PROPOSED GROUNDWATER MONITORING PLAN

TOMOKA FARMS ROAD LANDFILL

PROPOSED GROUNDWATER MONITORING PLAN FOR
TOMOKA FARMS ROAD LANDFILL
VOLUSIA COUNTY, FLORIDA

EVALUATION OF
MONITORING AT
TOMOKA LANDFILL

Figure 3. Water Levels, Wells FA-1, B-2

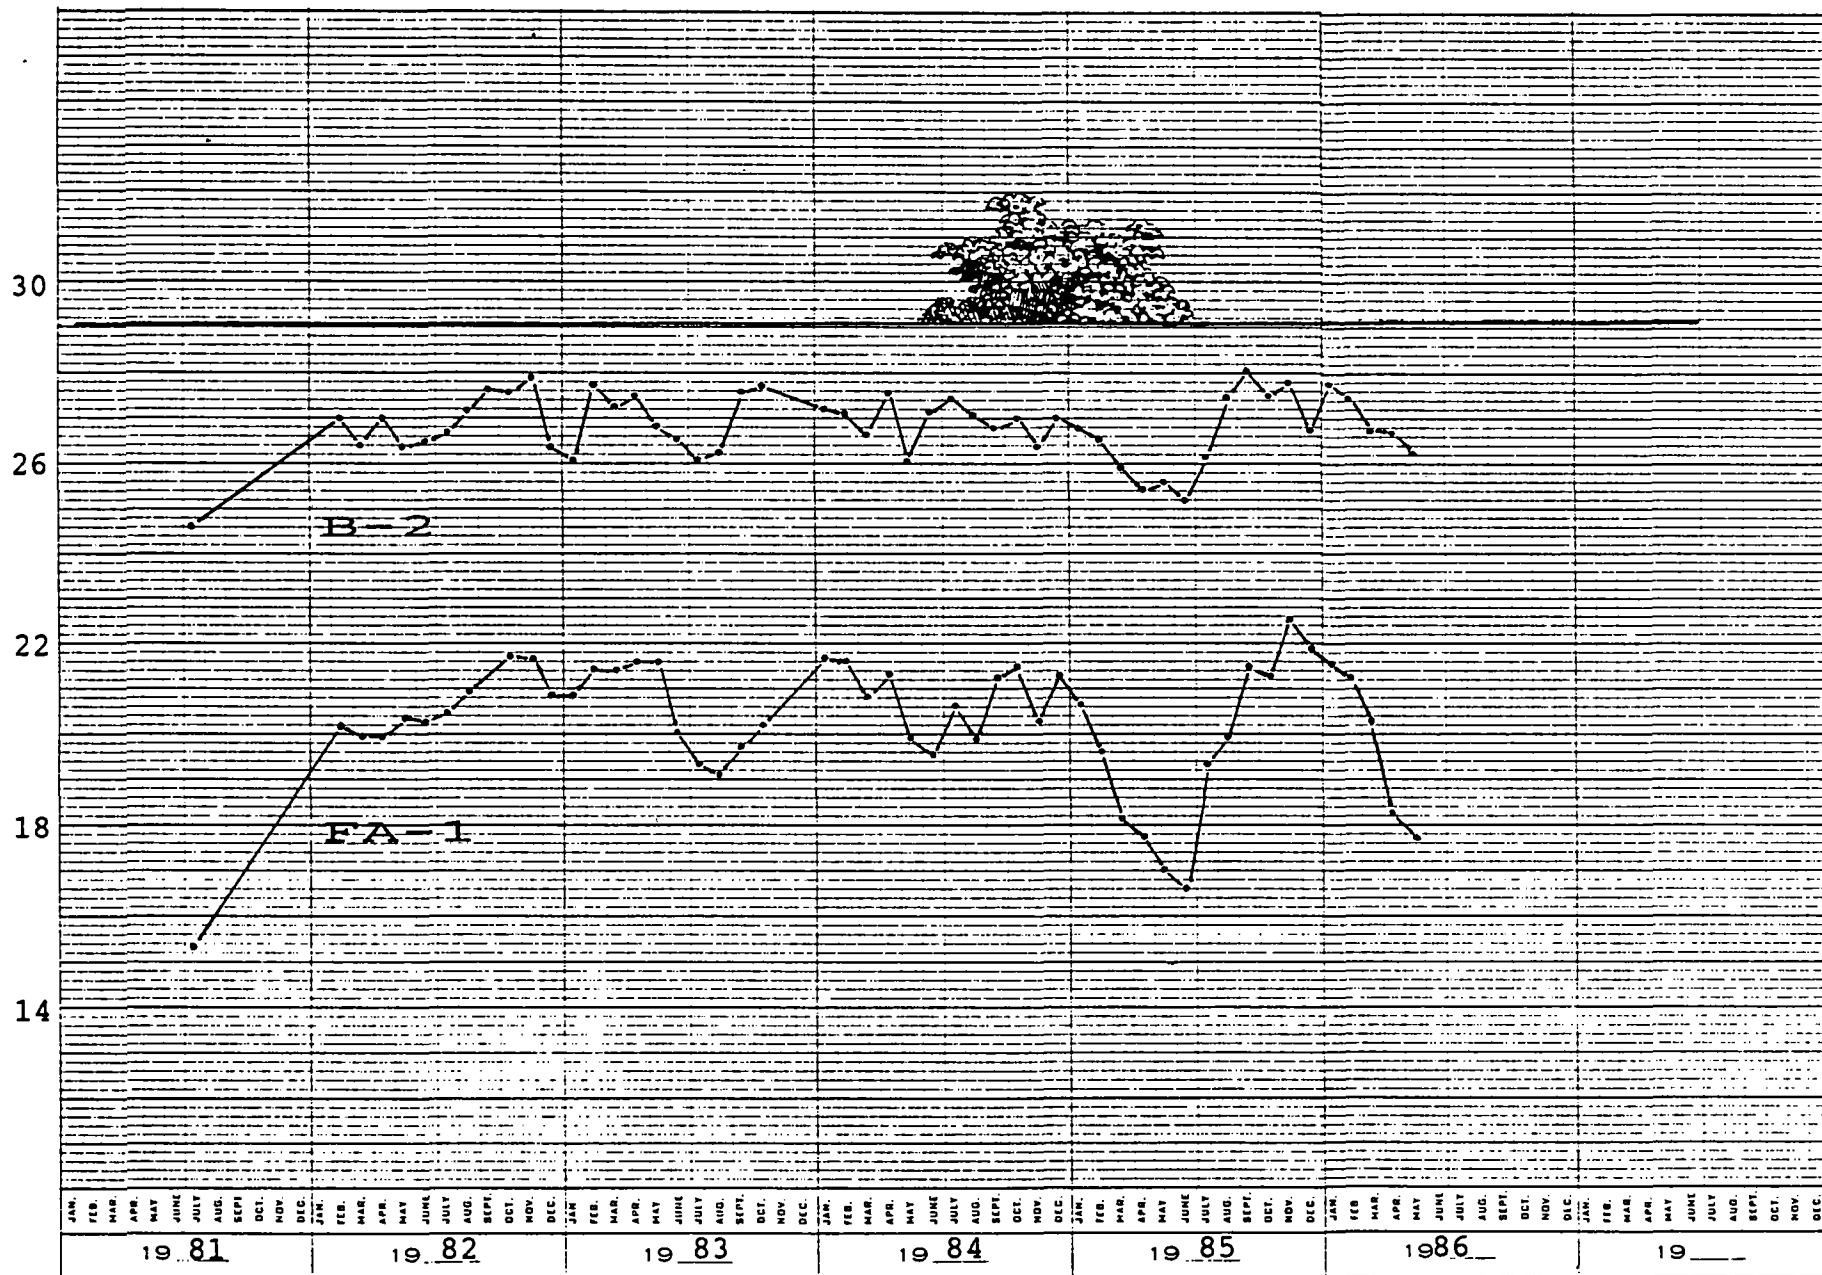
Figure 3, hydrographs of shallow well B-2 and deep well FA-1, illustrates natural differences between the water table and Floridan aquifers. Most prominent are the heads or potentiometric levels in the aquifers, with the Floridan Aquifer consistently lower than the water table. Over the 5-year period of record, this difference has varied between 1.2 and 2.3 feet at the site of wells B-2 and FA-1, and between 4.8 and 9.2 feet at the location of wells B-6 and FA-2 (Fig. 4). This head difference, or vertical gradient, is one of three factors, the others being the permeability and thickness of intervening sediments, controlling the rate and direction of flow between aquifers.

Figure 9. Iron in Monitor Wells

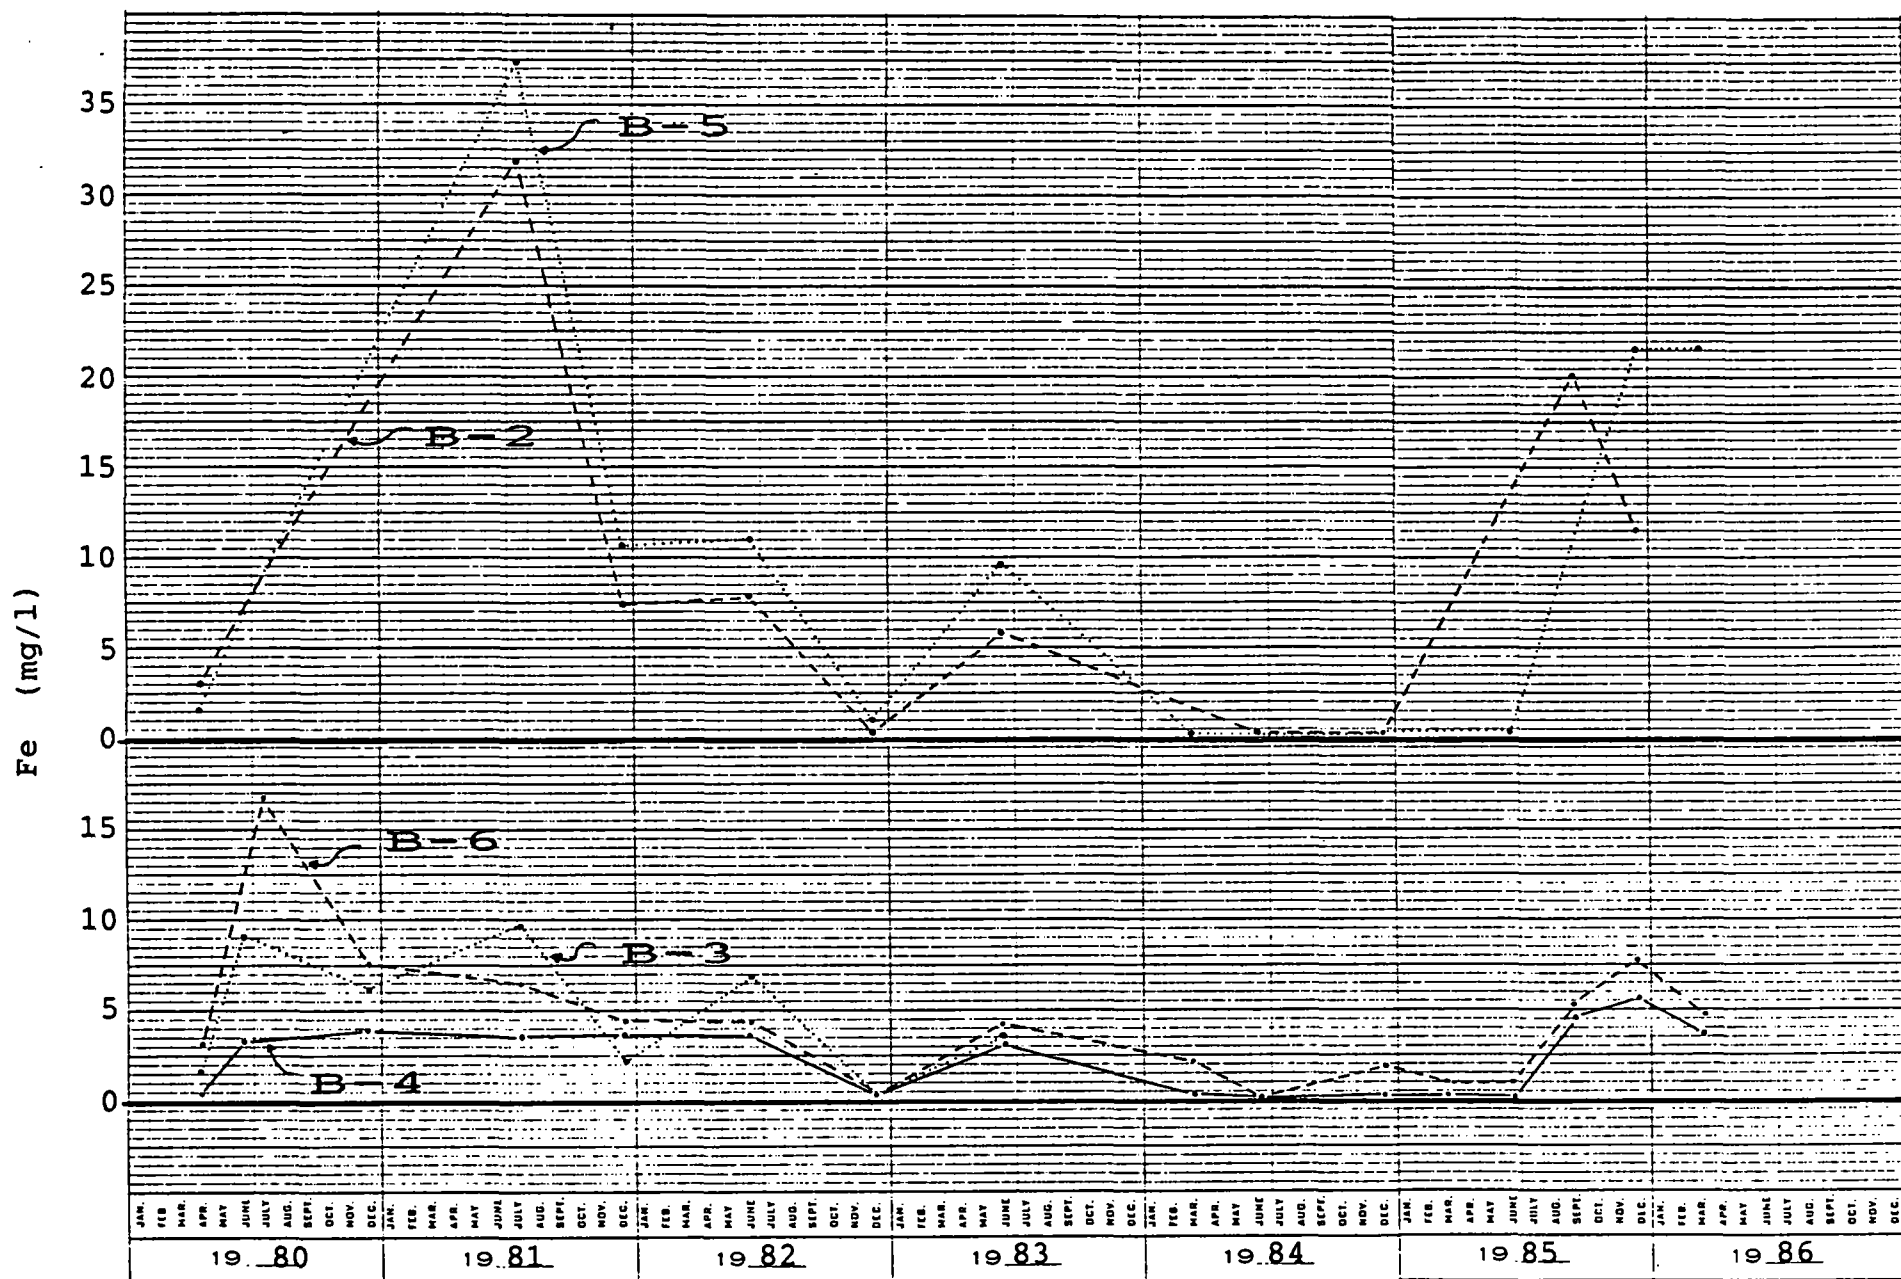
Figure 9 shows monitoring data for Iron, from wells B-2 through B-6. In addition to differences in absolute concentrations, the greater fluctuation of Fe levels in wells B-2 and B-5 is apparent, and suggests that the periodically high levels are not natural. As can also be seen, the Fe concentration in well B-6 was near or above selected background during part of 1980. These results for B-6 are puzzling, in that, even though downgradient from the landfill, it is not readily apparent how shallow groundwater flow could have raised Fe concentrations at this distant location. In addition, only Fe and possibly one COD value are above background, raising the issue of whether the choice of background concentration is too low. Further analyses and evaluation are needed to resolve these questions.
